Re: Former Chevron Service Station No. 90121  
3026 Lakeshore Avenue  
Oakland, California  
Fuel Leak Case RO0000284

Reference No. 311973

**Re: Technical Response and Work Plan  
Former Chevron Service Station 90121  
3026 Lakeshore Avenue  
Oakland, California  
ACDEH Case No. RO0000284**

SITE PLAN

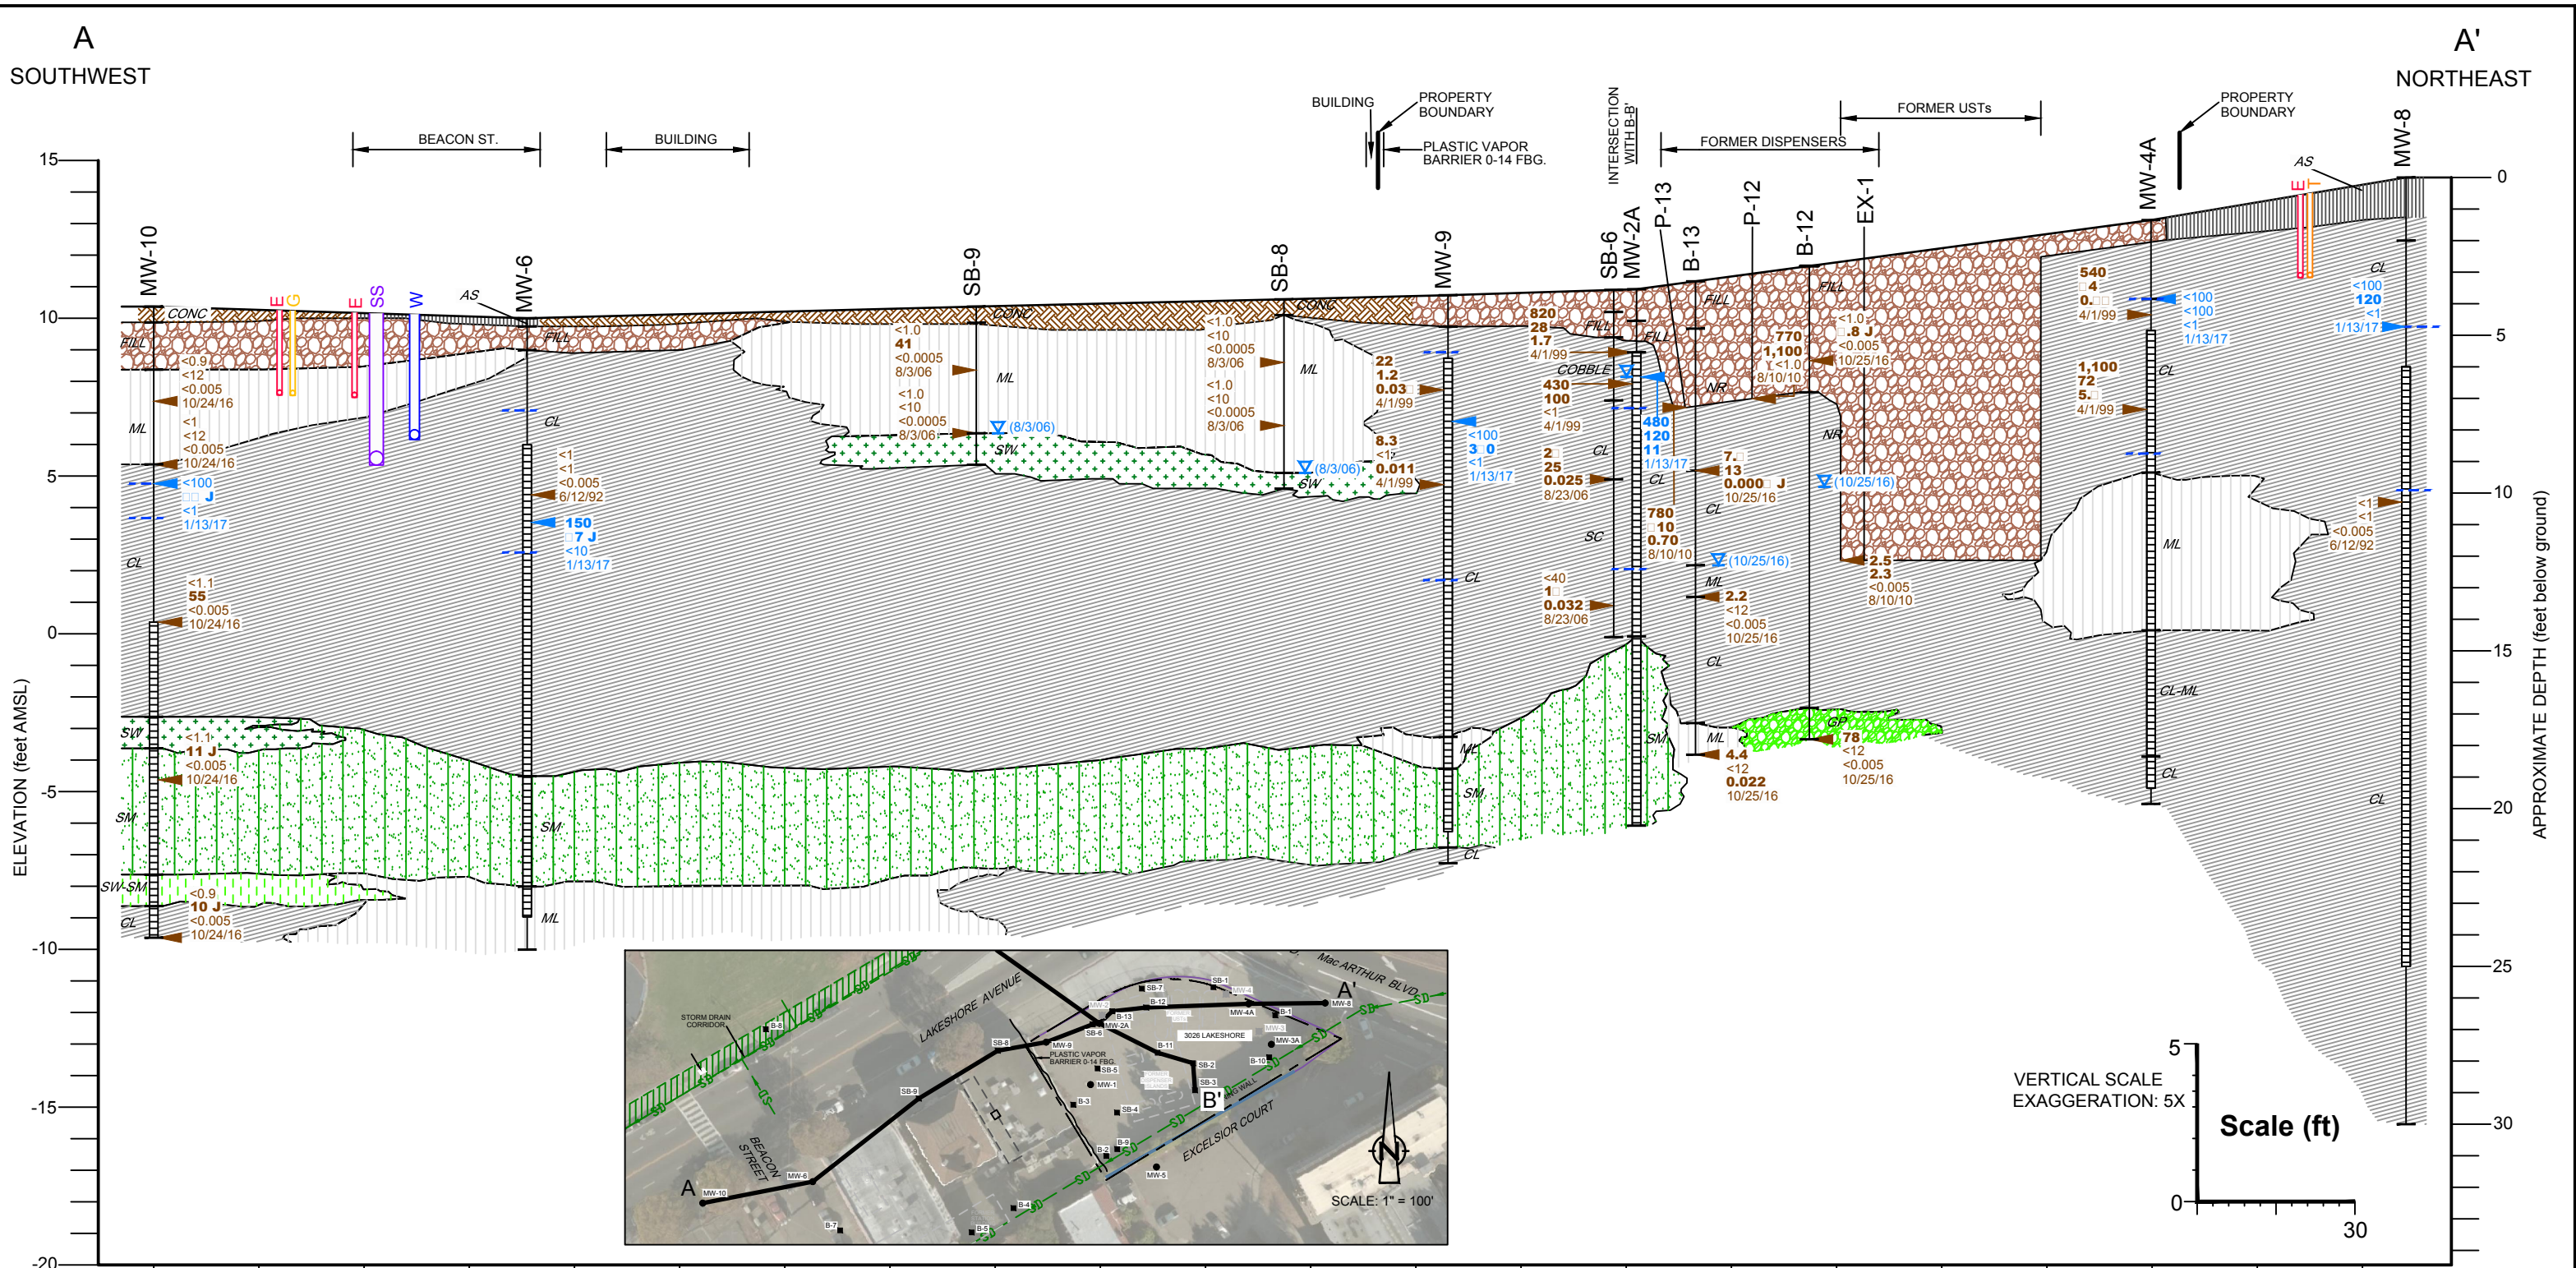
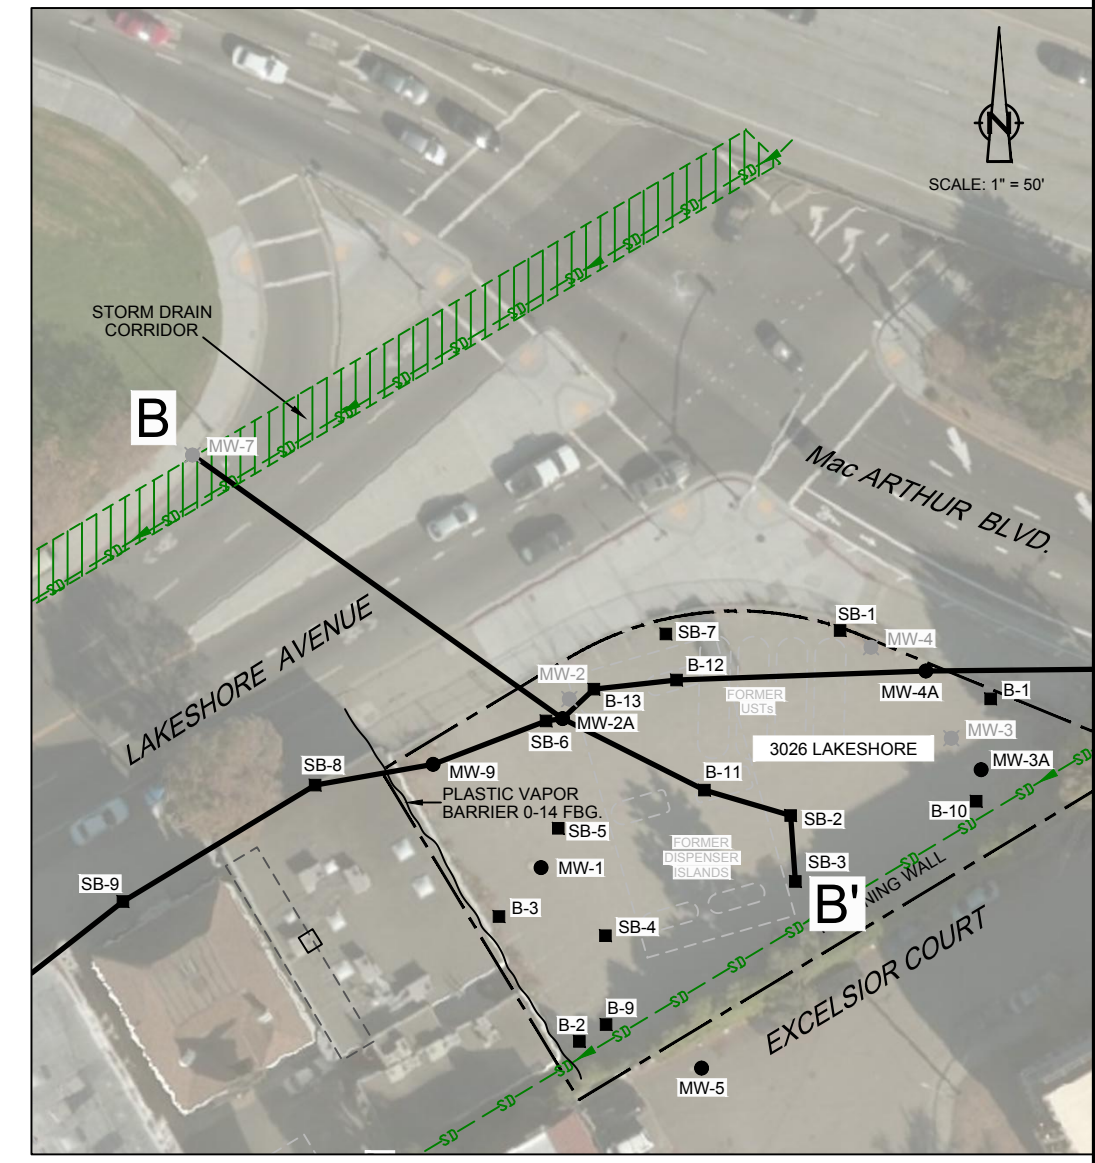
*Response:* The location of the two USTs abandoned in place beneath the sidewalk has not been located in any historical files or during the 2011 geophysical survey conducted in the sidewalks of Lakeshore Avenue and MacArthur Boulevard. Figures 3, 6, 7, and 8 have been updated with known locations of former facilities and the dates those facilities were in place.

To evaluate the potential for hydrocarbon vapor migration from the subsurface to indoor air of future structures on the site as well as the adjacent downgradient building, GHD proposes installing and sampling three nested soil vapor probes at 2 and 5 fbg. To evaluate current indoor air and basement conditions at the adjacent site, GHD proposes sampling the existing sub slab probes and collecting ambient indoor, crawl space, and outdoor air samples. Proposed probe and sampling locations are illustrated on Figures 2 and 3.

**FIGURE 4**  
**GEOLOGIC CROSS SECTION A-A'**  
**FORMER CHEVRON SERVICE STATION 90121**  
**3026 LAKESHORE AVENUE, OAKLAND, CALIFORNIA**

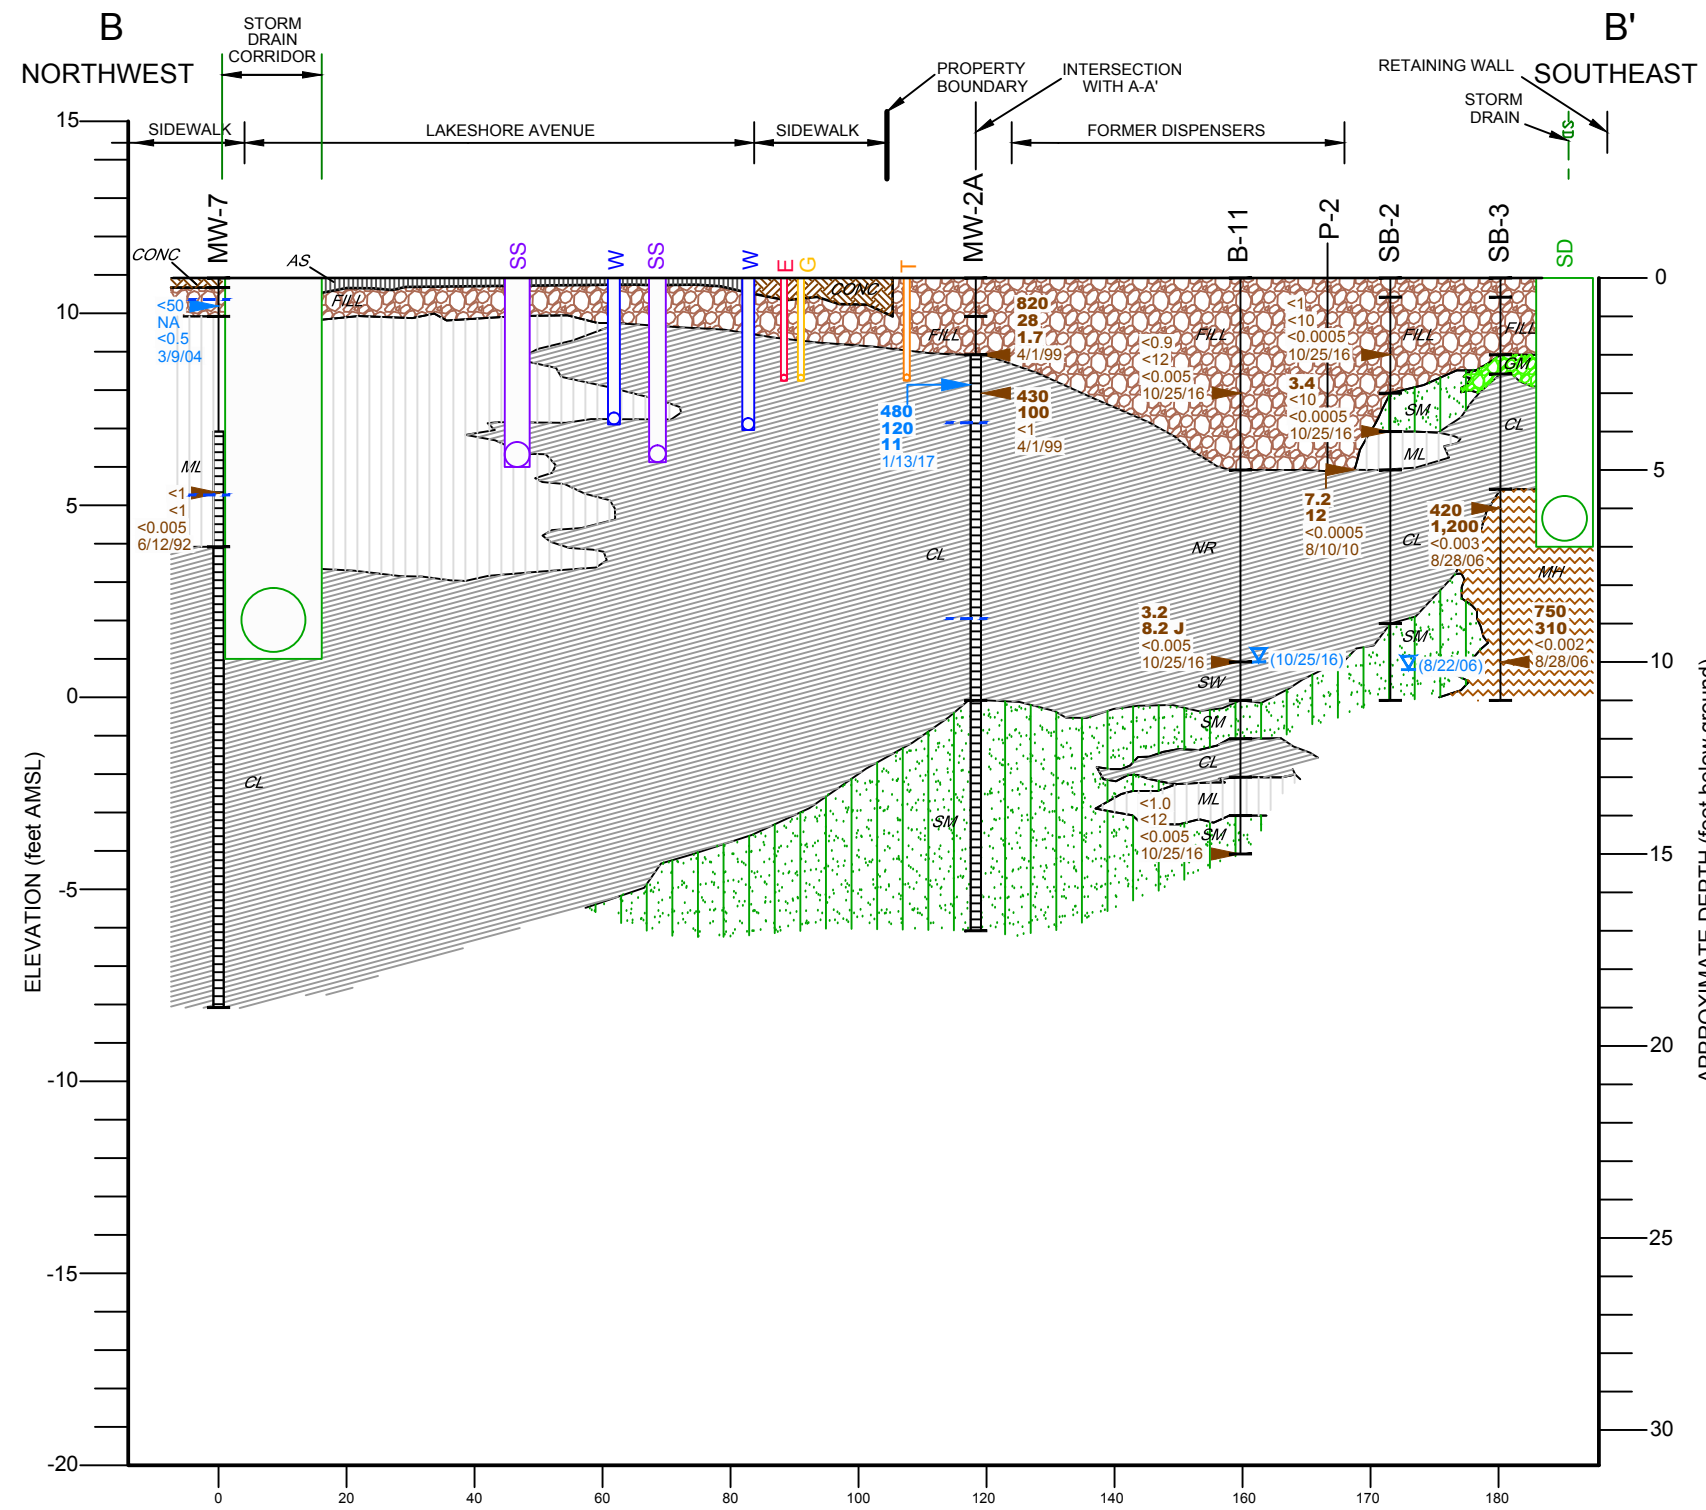
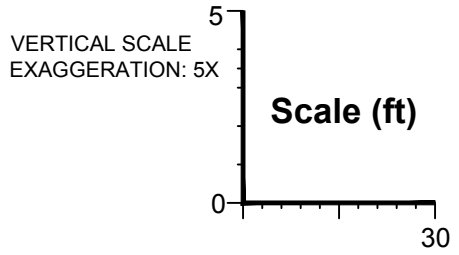
As requested by ACDEH, geologic cross-sections including utility depths and historical high groundwater depths are included as Figures 4 and 5. Figures illustrating the lateral extent of TPHg (0 to 5 fbg) and benzene (0 to 5 and >5 to 10 fbg) in soil are included as Figures 6, 7, and 8. As illustrated, hydrocarbons in soil are centered on the former three generations of dispenser islands and product piping and extend downgradient to the west and southwest to B-3. A cumulative soil table documenting remaining hydrocarbons in soil and soil that has been removed is included as Table 1. A table documenting well construction details is included as Table 4.
